RESIDENTIAL DEVELOPMENT
SITE AT HERITAGE GATE
COED DARCY
PHASE 2

HOUSETYPE W1A
PLANS & ELEVATIONS
EXISTING AND PROPOSED

9117 PH2-S73-PL12

SIDE ELEVATION 1 (EXPOSED)

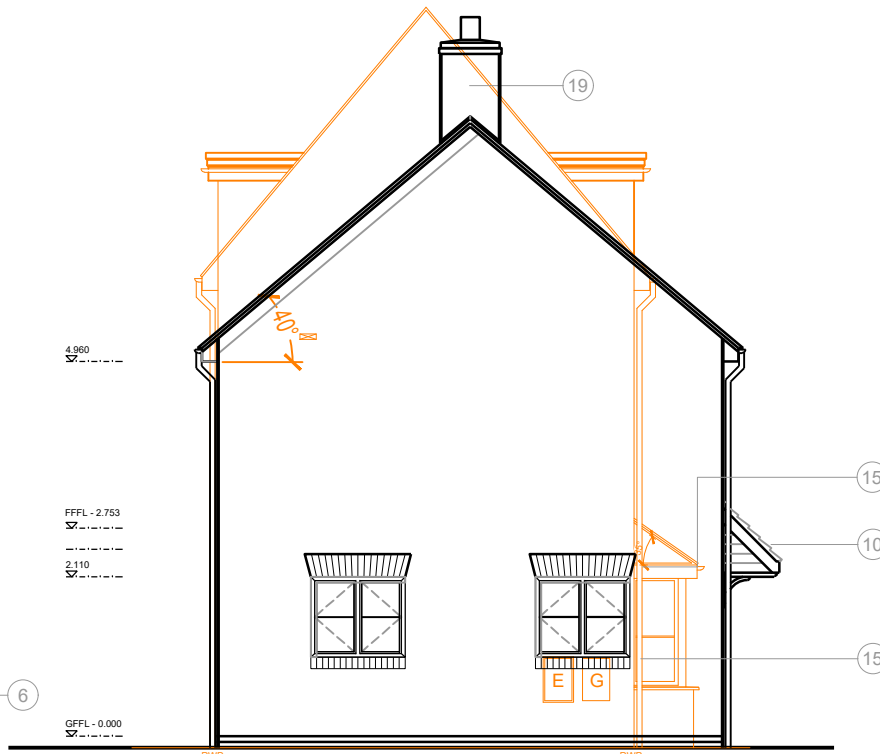
rev.	date	description
A	14.08.20	Updated to LPA's comments: first floor windows (side elevation) removed;
